**Town of Hilton Head Island**  
**Regular Design Review Board Meeting**  
**Tuesday, January 9, 2018 – 12:00 p.m.**  
**Benjamin M. Racusin Council Chambers**  
**AGENDA**

***Town of Hilton Head Island***  
***Minutes of the Design Review Board Meeting***  
**December 12, 2017 at 1:15 p.m.**  
**Benjamin M. Racusin Council Chambers**

**B** Garage Door  
3/4" = 1'-0"

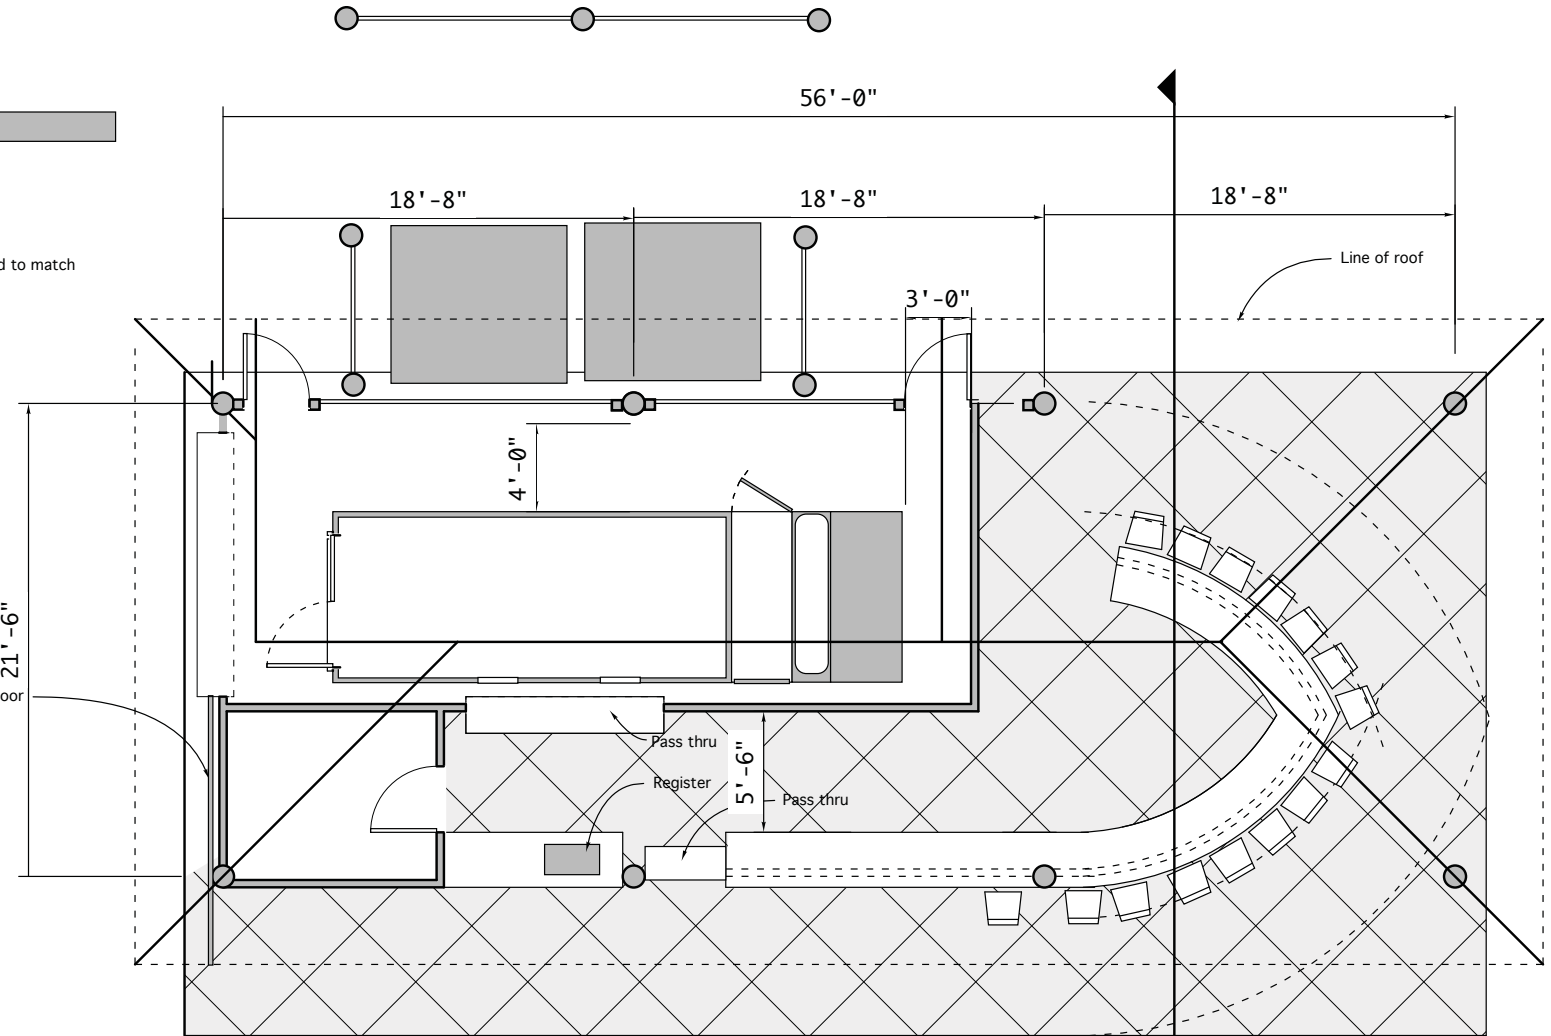
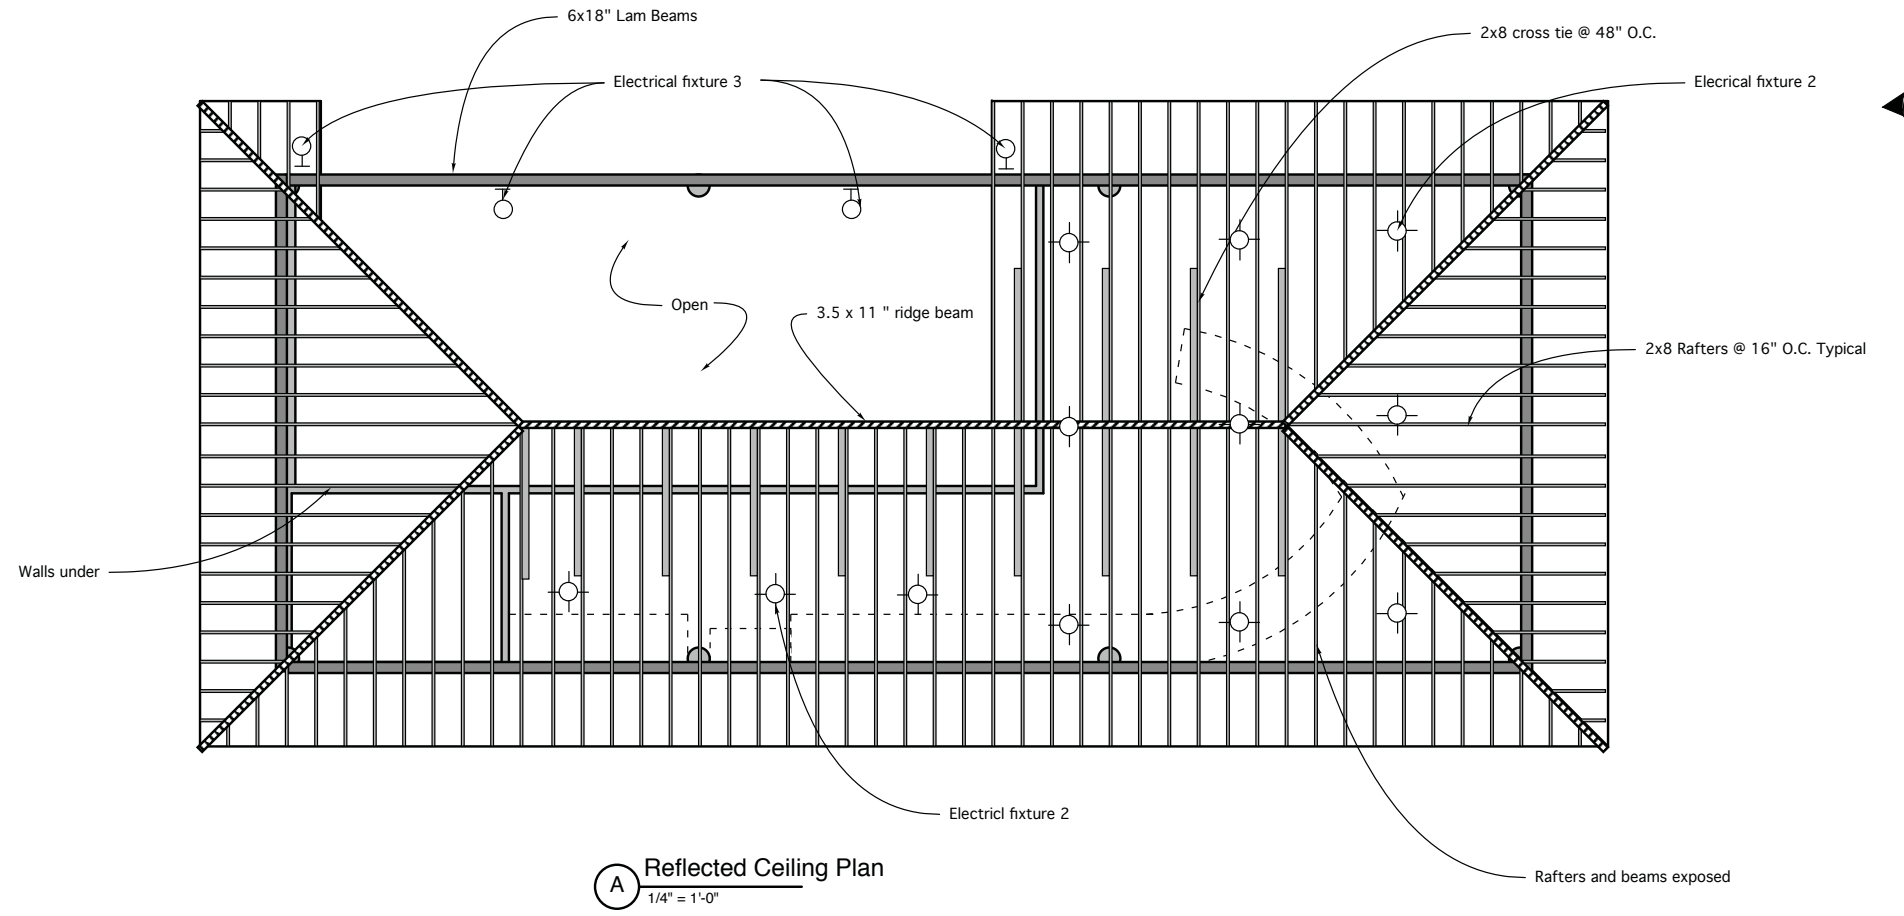
3) a detail of the garage door and pass thru window was requested.  
this has been provided on Sheet A2.1

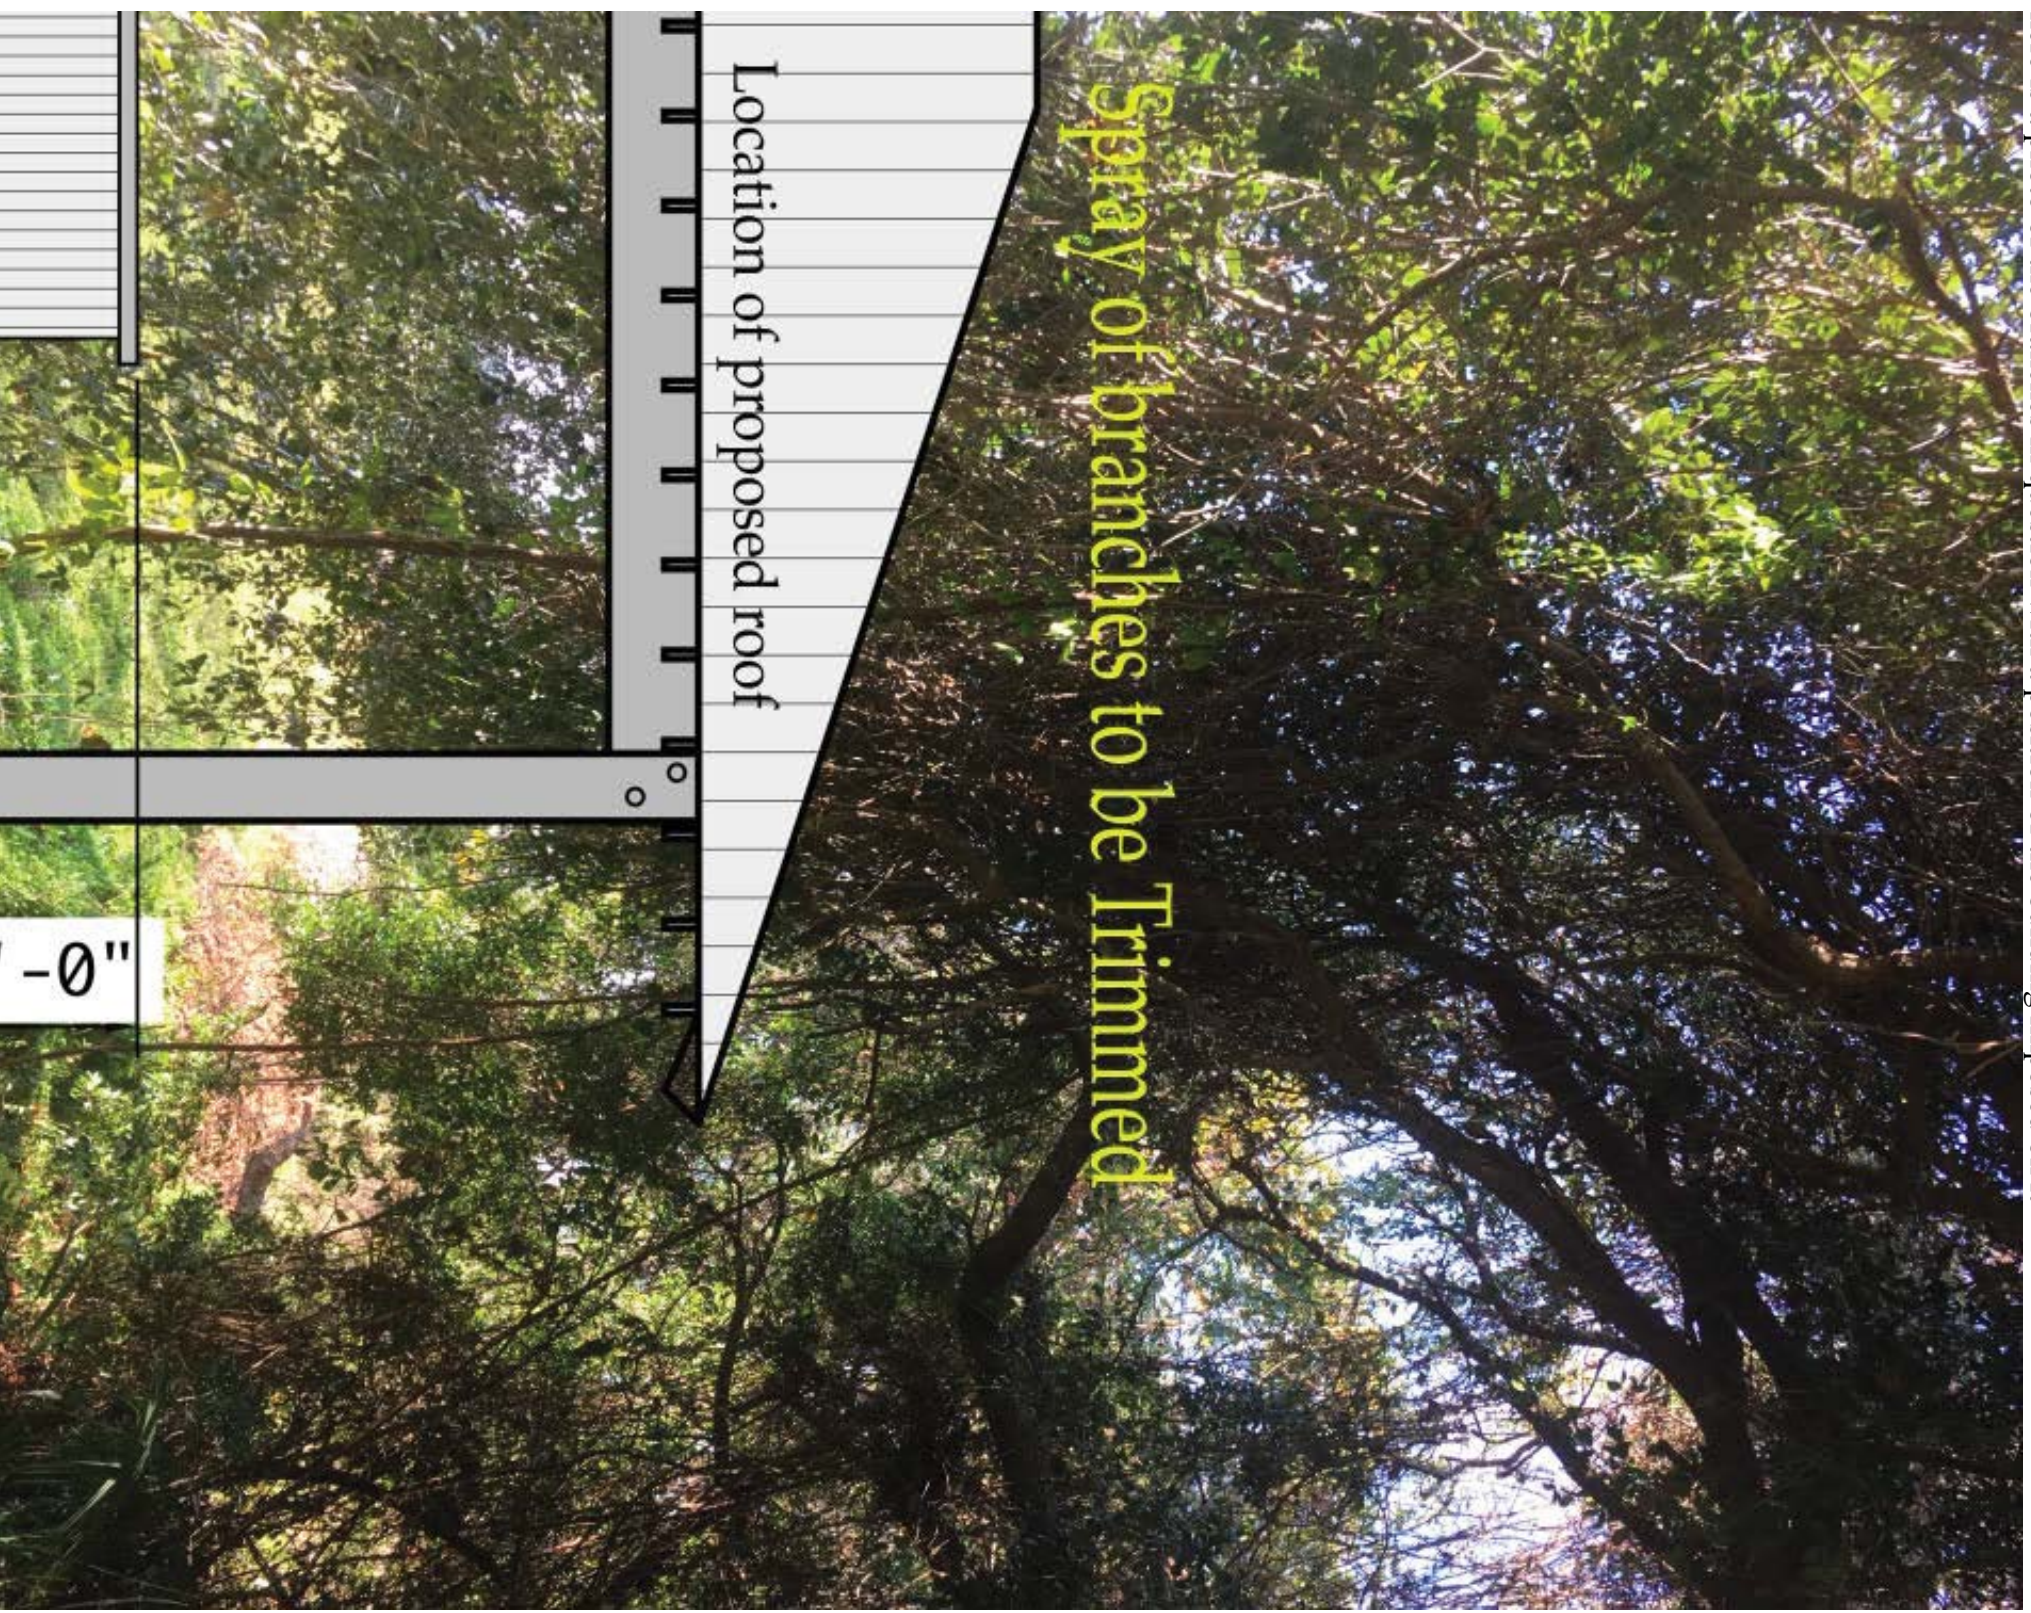
the Arborist we are planning to use is Michael Murphy.  
here is a photo of the branches in question with a position of the building imposed on it
